DCP/NRC1021
NSD-NRC-97-5307
Docket No.: 52-003

SUBJECT: AP600 RESPONSE TO REQUEST FOR ADDITIONAL INFORMATION

OITS: 5461
RAI: 480.1023

SECTION 12, "CLIME NODING STUDY," OF WCAP-14407, "WGOthic APPLICATION REPORT"

Figure 480.1023-1 Test 219.1 Heat Rate into Containment Shell

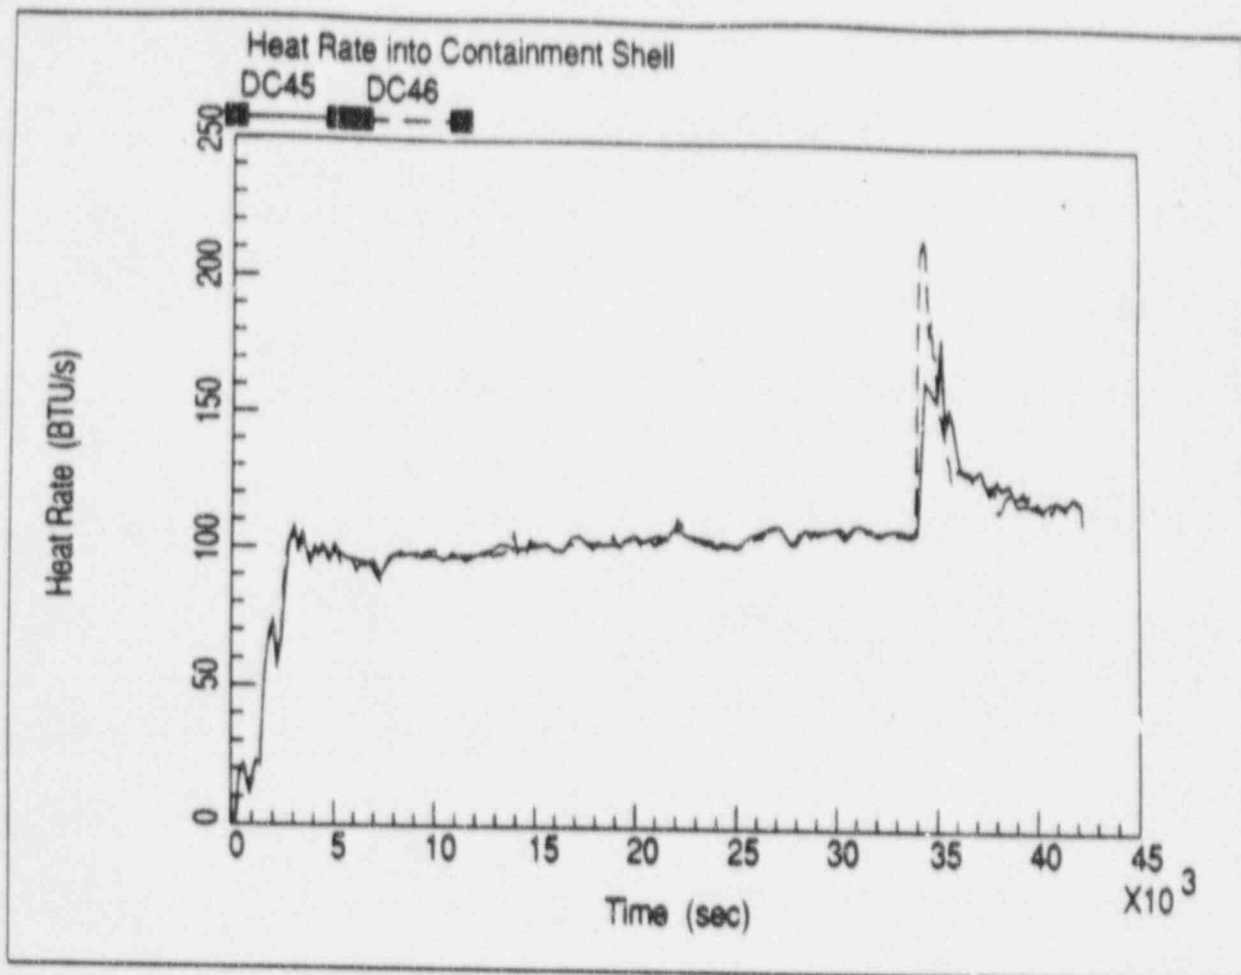
The applicant needs to provide an evaluation of the differences between WGOthic Versions 1.2 and 4.1 on the previous calculations presented in the "WGOthic Code Description and Validation" report, WCAP-14382. This evaluation should present a technical justification why these existing calculations remain valid, and consider the "ccvel" subroutine and the changes to the annulus inertia lengths. Those calculations deemed most likely to be impacted by the change from Version 1.2 to Version 4.1 should be rerun (at a minimum, Tests 214.1A, 214.1B, 216.1B, 219.1A, 219.1B, 219.1C, and 222.4B) and provide comparison plots of pressure, passive containment cooling system (PCS) air and film temperature, heat flux, and heat removal rate.

The predicted heat rate into and out of the containment shell are shown in Figures 480.1023-1 and 480.1023-2, respectively. The heat rate for version 1.2 is higher than version 4.1 when the water is first put onto the vessel due to the method used to determine clime dry out. The corrected clime dryout model used in version 4.1 results in a lower predicted heat rate. Clime dryout occurs from 34,400 seconds - 35,400 seconds, and at 35,800 seconds, during the initial water application. After the initial spike, a quasi-steady heat removal rate equivalent to the net steam energy delivery rate (which remained essentially constant through the transient) is reached, at which time the vessel pressure is significantly reduced due to the addition of water cooling.
